Reference: EDC/25/0233

Site Address: Ashmere Parcels 12 & 13 (Western Village), Eastern Quarry, Watling Street, Swanscombe, Kent

Proposal: Reserved matters application (relating to access, appearance, landscaping, layout and scale) pursuant to condition 2 (details of reserved matters), condition 25 (reserved matters design details) and condition 28 (noise report) of outline planning permission EDC/17/0048 for 143 dwellings and associated infrastructure.

Applicant: Dandara South East

Image: Extract from the AMP/DC showing the requirements for density (left image) and build heights (right image) at the application site:

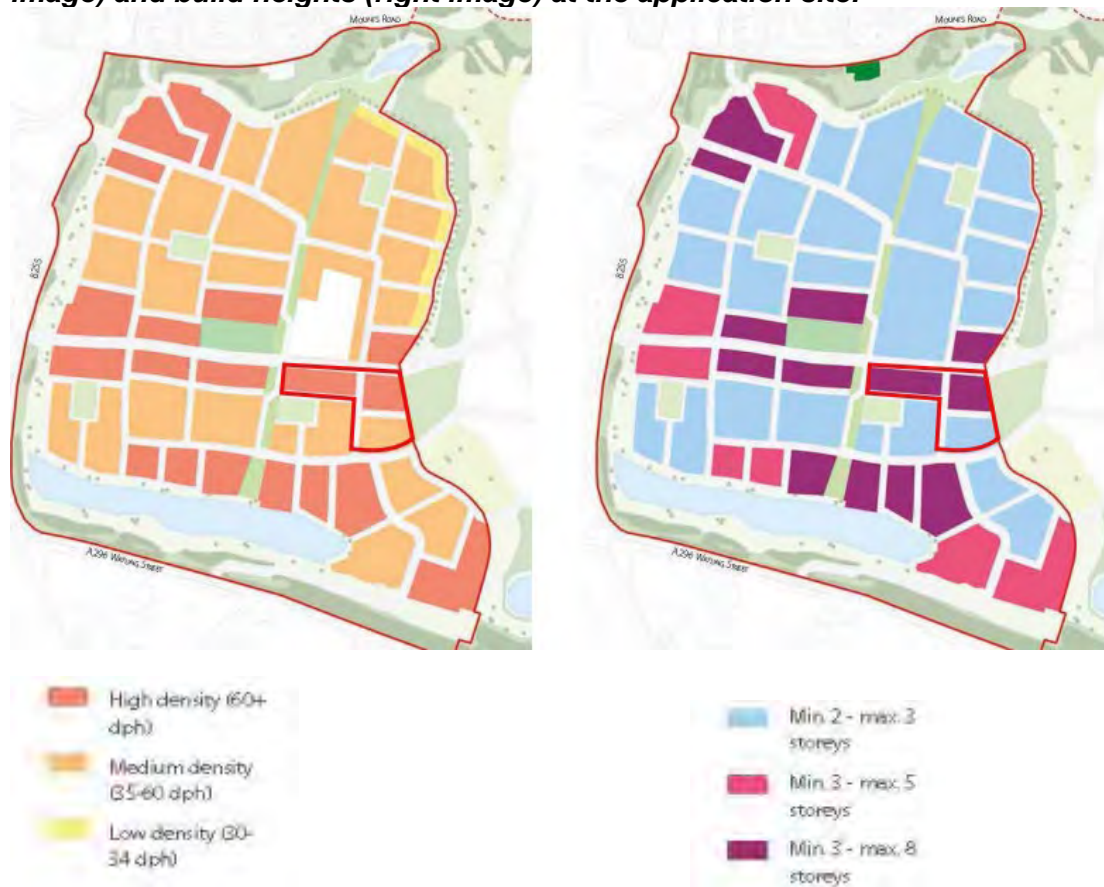
- 6.31 The AMP/DC designates Parcel 12 of the application site as a mixed density parcel, where higher density (60+dph) occupies the northern section of the site along Fastrack, whilst medium density (35-60dph) occupies the southern section. The AMP/DC designates Parcel 13 as high density (60+dph). This is shown by the image below on the left. Additionally, the image on the right shows the building heights, where the higher density parts of the site should deliver buildings with a minimum of three

storeys and a maximum of eight storeys. Meanwhile, the remaining built form should be limited to a minimum of two storeys and a maximum of three storeys.

- 6.32 Density has been distributed in accordance with the approved parameters, achieving over 60 dwellings per hectare (dph) in Parcel 13 and the northern section of Parcel 12 and between 35 and 60 dph in the southern section of Parcel 12, resulting in an overall site density of approximately 55 dph. This variation in density complements the changes in building height and massing, creating a legible hierarchy of spaces and reinforcing the character areas identified in the AMP/DC.
